# 2000-F12-SCM-EL-10213_Rev1

F12-SW-001 F12-FA-401 primary crusher 2 discharge apron fe schematic and termination diagram

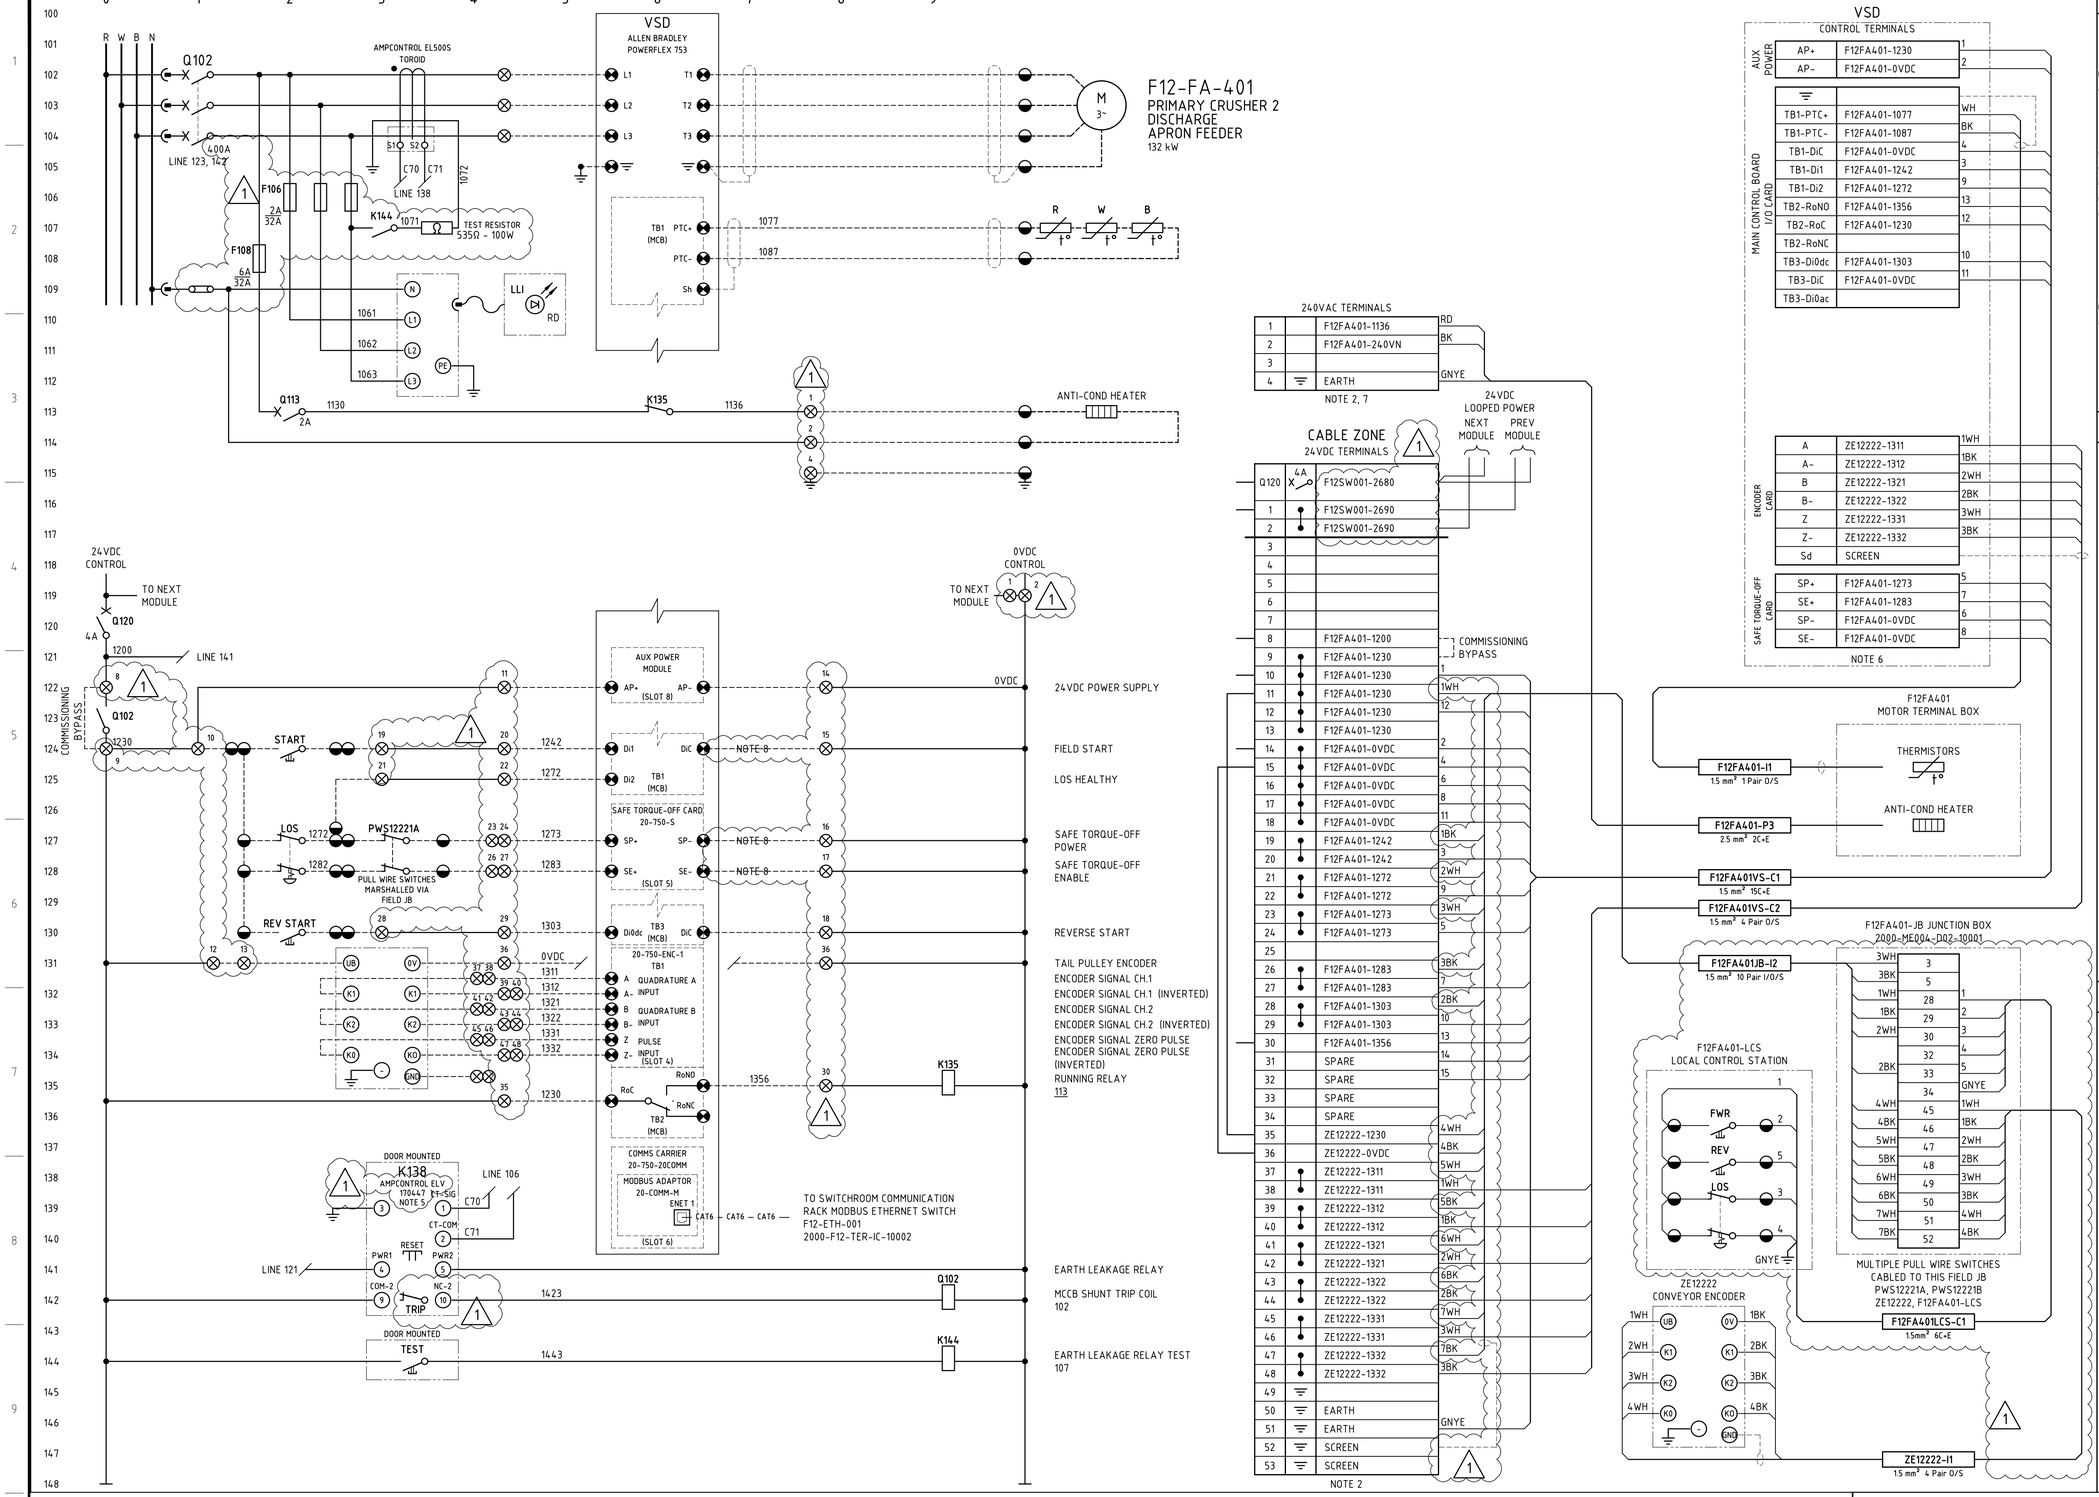
1. TERMINALS ON TERMINAL STRIPS ABOVE 50VAC SHALL HAVE A SEPARATE PERSPEX SHROUD AND SHALL BE LABELLED "DANGER xxxVAC".
2. WIRE NUMBER FERRULES ON TERMINAL STRIP SHALL BE PREFIXED WITH EQUIPMENT NUMBER e.g. F12FA401-1200, UNLESS OTHERWISE NOTED. (1)
3. EACH WIRE SHALL BE IDENTIFIED AT BOTH ENDS WITH FERRULES.
4. AMPCONTROL 101656 100/1A TOROID. (1)
5. EARTH LEAKAGE RELAY (ELV) USER INTERFACE TO BE MOUNTED ON MCC MODULE DOOR. RELAY ENERGISED (NORMALLY CLOSED CONTACT OPEN) IN NORMAL OPERATION.
6. VSD SHALL BE FRAME SIZE 5 AND ABOVE.
7. 240VAC TERMINALS FOR THE HEATER CIRCUITS SHALL BE LOCATED IN THE MCC DRIVE MODULE.
8. SITE TO MARK UP 0VDC LINKING IN THE VSD AS THE SWITCHROOM MANUFACTURER HAS NOT PROVIDE THIS WIRING DETAIL. (1)
